Informal document No. GRRF-60-04 (60th GRRF, 18-22 September 2006, agenda item 1.1.4.)

STOP LAMP ILLUMINATION

<u>Transmitted by the experts from the European Association of Automotive Suppliers (CLEPA) and</u>
<u>from the International Organization of Motor Vehicle Manufacturers (OICA)</u>

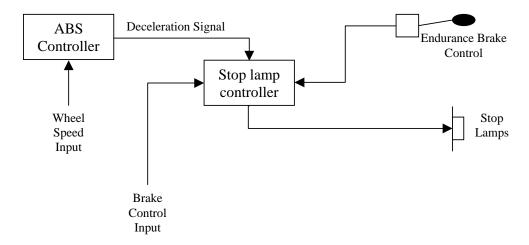
As requested industry have considered the content of GRRF-59-11 and have come to the conclusion that while it is possible for an ABS equipped vehicle to provide deceleration information there are significant cost, vehicle and brake system specification implications as follows:

<u>Vehicle Interfaces</u> – in the case of EBS equipped vehicles interfaces between the braking system, endurance brake and the vehicle control system already exist therefore defining a deceleration requirement for such vehicles requires minimal change. However, ABS vehicles do not have this interface therefore they would require modification to include an interface system as illustrated below:
